STATE OF VERMONT
AGENCY OF TRANSPORTATION

PROPOSED IMPROVEMENT
BRIDGE PROJECT

ROUTE NO: TH 18 CLASS 3 BRIDGE NO: 17

RECORD PLANS

Designed By Y I LIU	Drawn By W J GAYNOR
Checked By B P GUZAS Date 8/09	Bridge Design Supervisor R L JOY Date 10/09
PROJECT RIPTON	PROJECT NO. FH 010-1(2)
I.G.C. Info.	
Bridge Sheet No.	Sheet 23R of 26

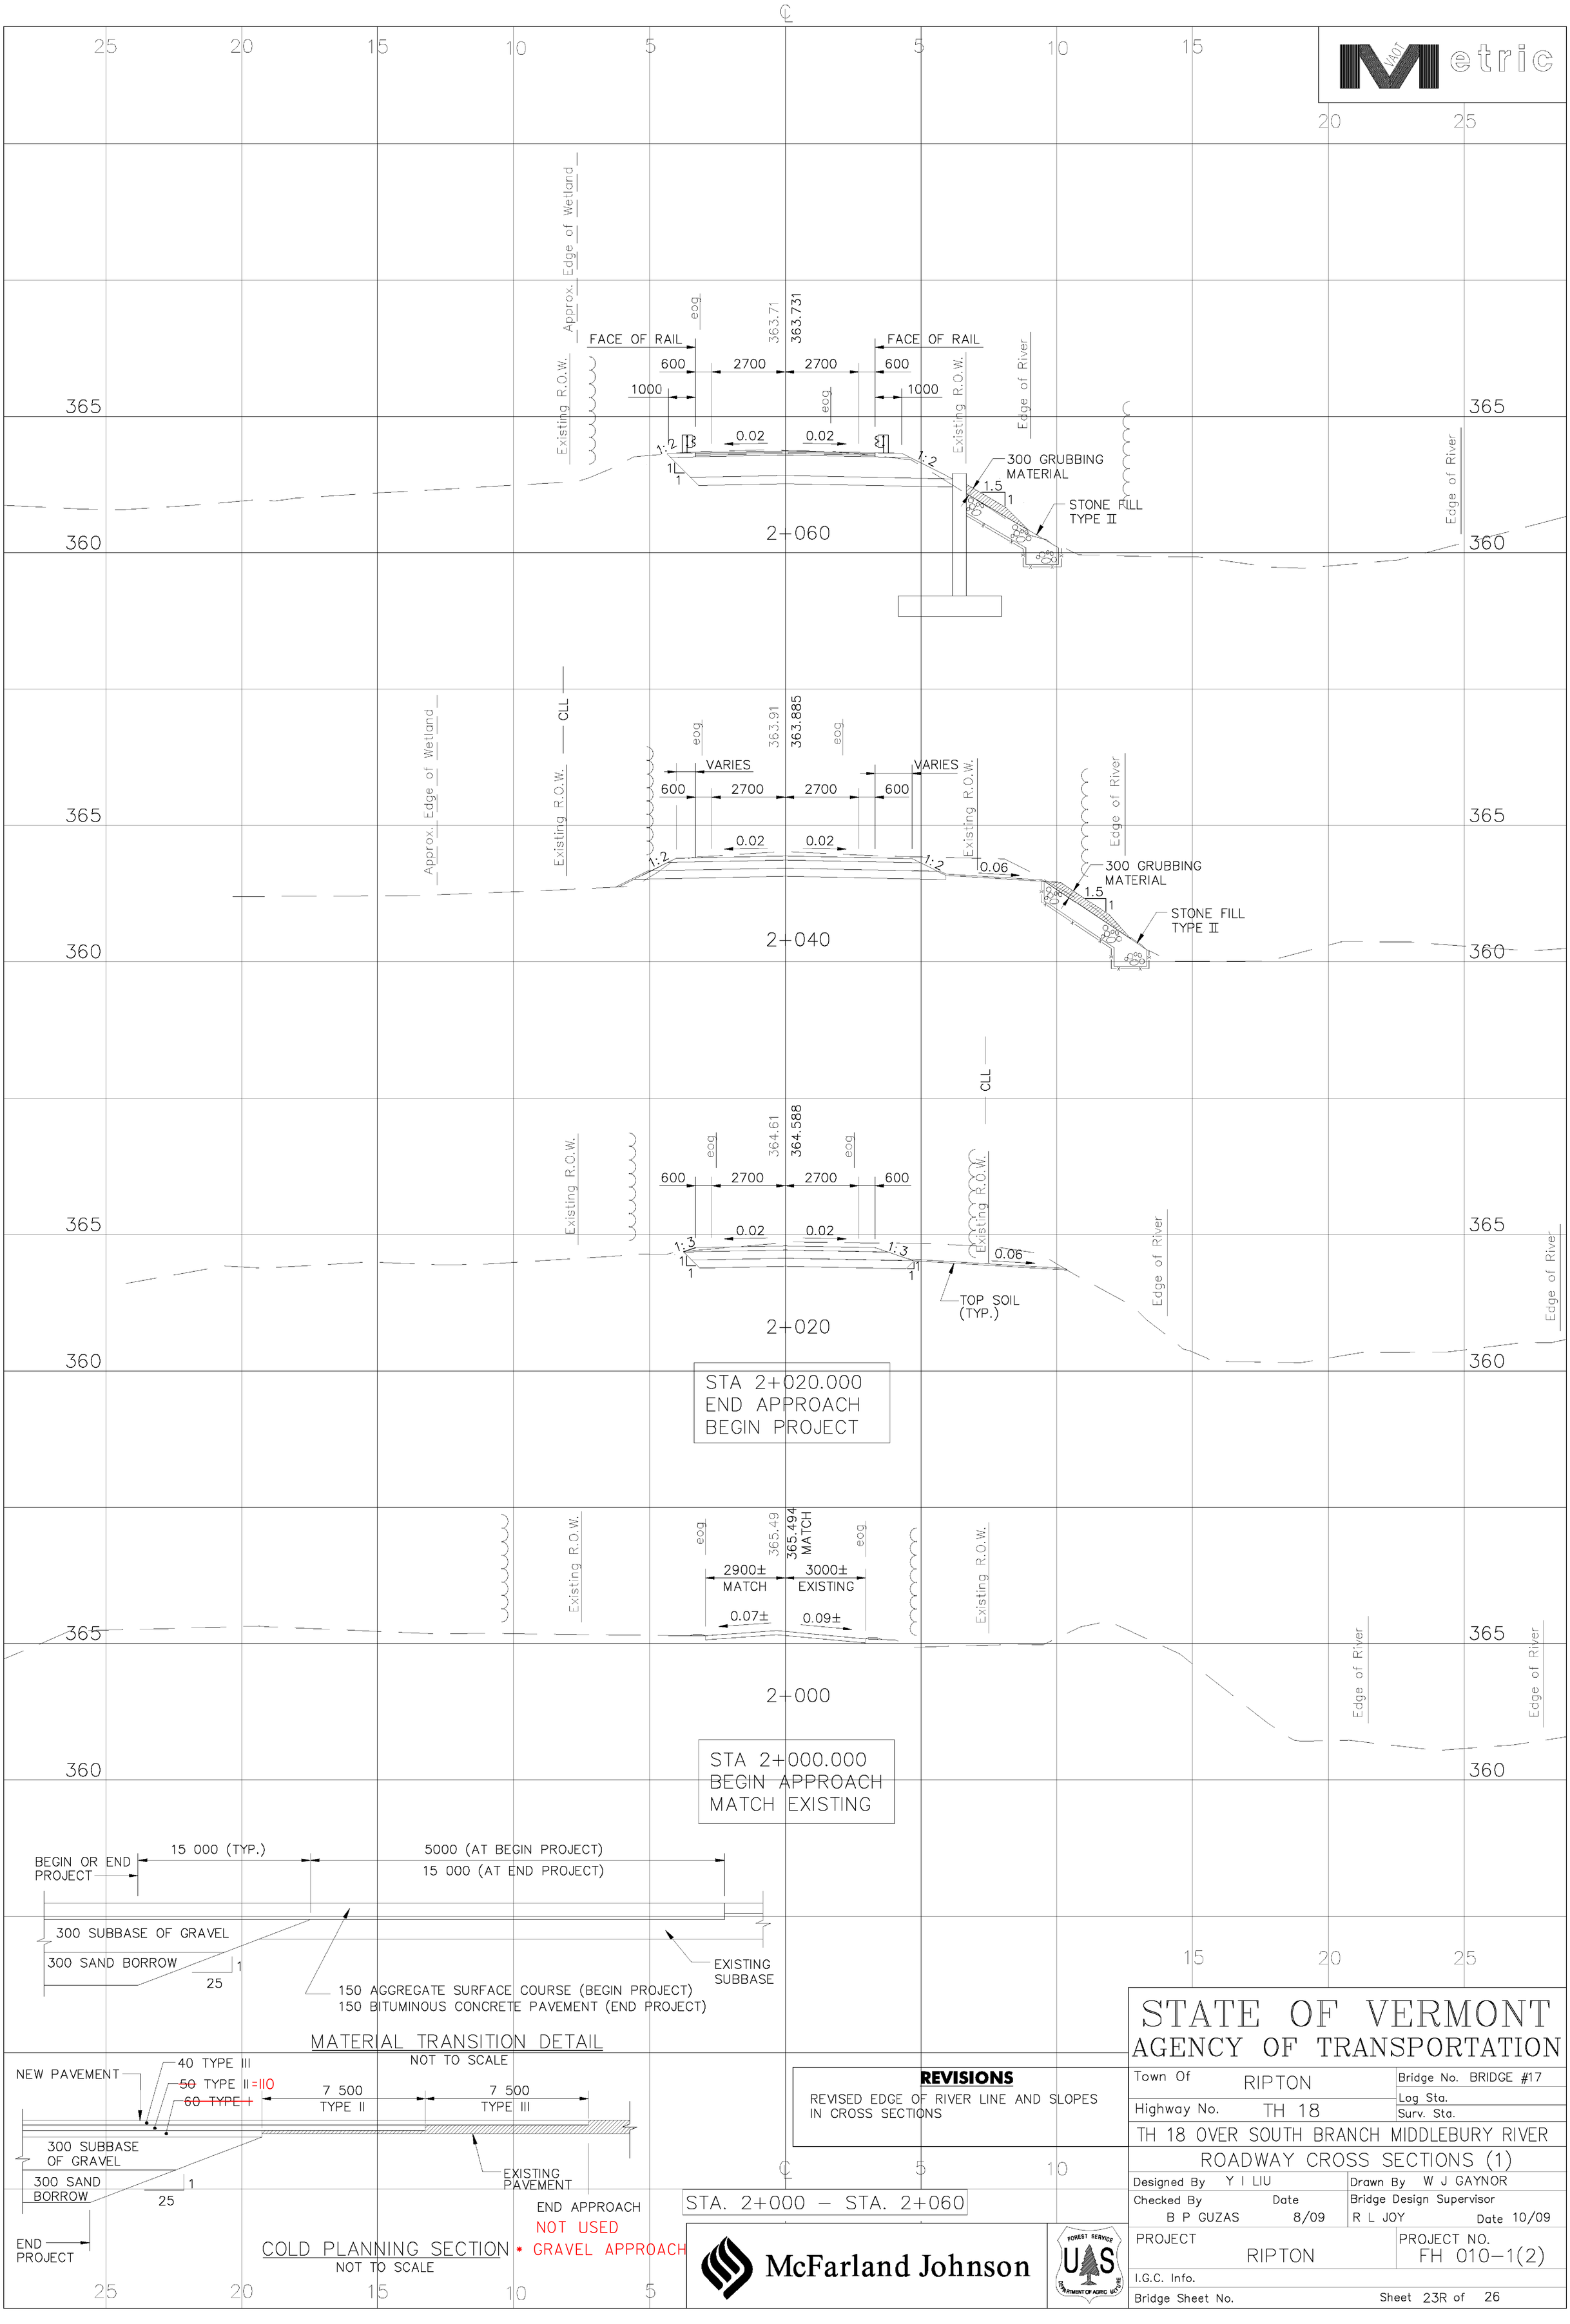
REVISED EDGE OF RIVER LINE AND SLOPES IN CROSS SECTIONS

REVISED ABUTMENT #2 SECTION
SCALE: 1:50

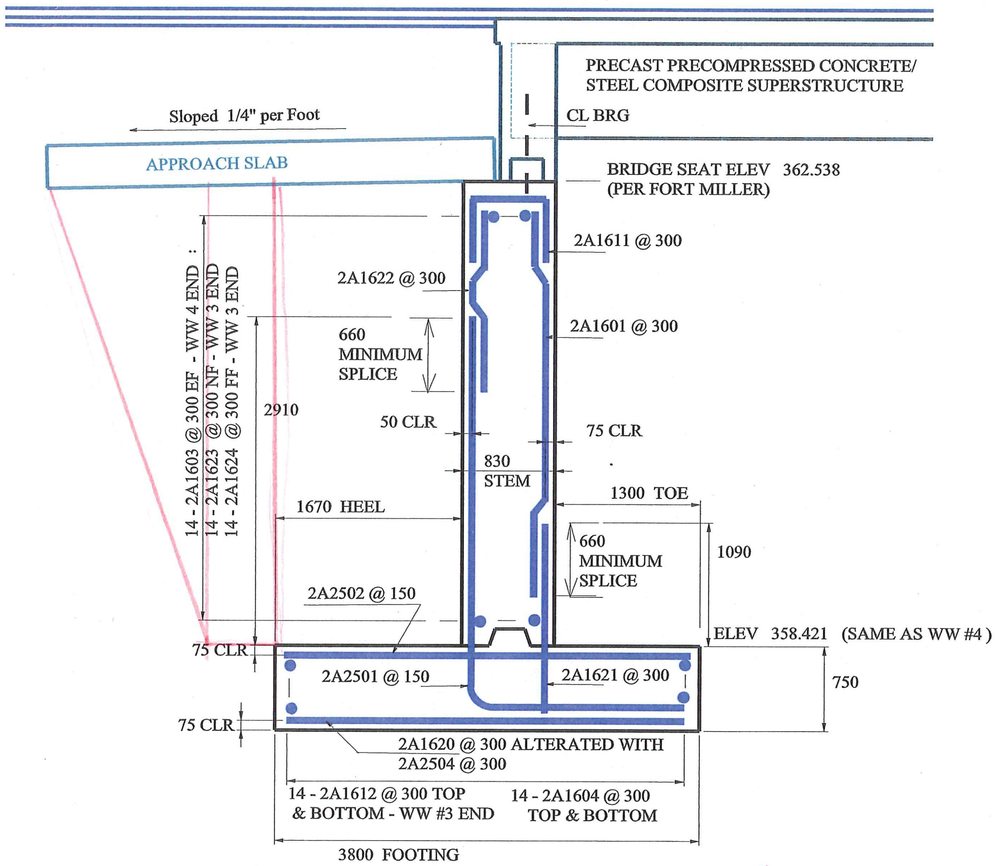
1. REBAR MARK "A1606 @ 300" SHALL BE DRILLED AND GROUTED INTO WINGWALL #3 AT LEFT END OF ABUTMENT AS CALLED FOR IN OCT 2009 PLANS SHEET 20R OF 26.
2. AFTER THE SUPERSTRUCTURE IS SET THE TWO PRECAST APPROACH SLABS SHALL BE SET WITH THE 25 mm GAP AND THEN HOLES DRILLED INTO THE ABUTMENT STEM FOR THE 600 mm REBAR.

REVISED ABUTMENT #2 PLAN
SCALE: 1:50

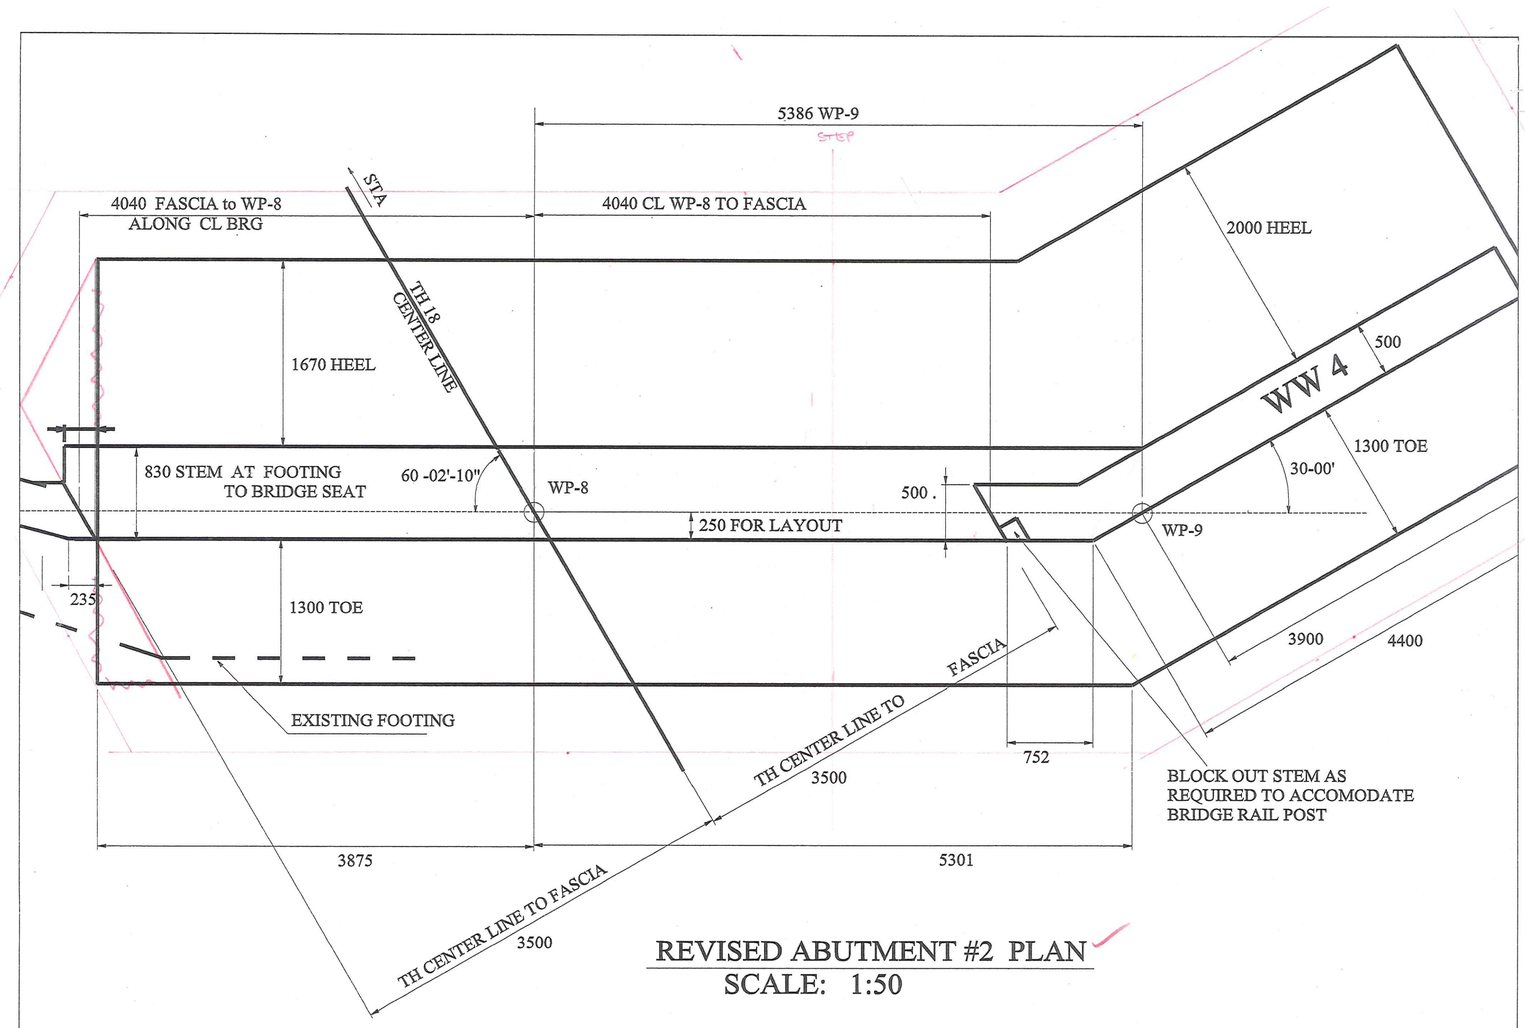
NOTES: 1. THE WORKING POINTS (WP) LAYOUT HAVE NOT CHANGED. WW #4 IS IN THE SAME LOACTION.
